***Eagle River Mine T1 Replacement
Notification of Conditional Approval of Connection Proposal
CAA ID Number: 2007-EX334***

ASSESSMENT SUMMARY

Wesdome Gold Mines Ltd.

Figure 1: Eagle River Mine (previously known as River Gold Mine)

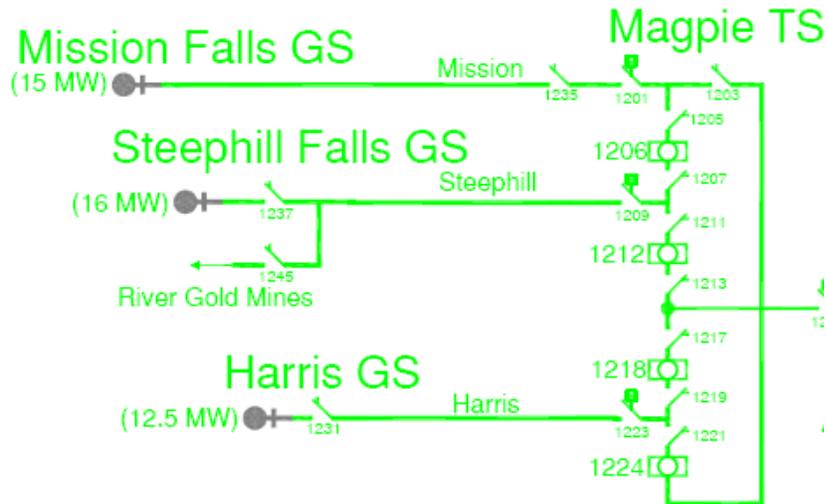
Transformer T1 at Eagle River Mine was replaced due to failure in March 2007. This transformer is connected to the 115 kV Steephill line out of Magpie TS. The facility is currently undergoing a name change from River Gold Mine.
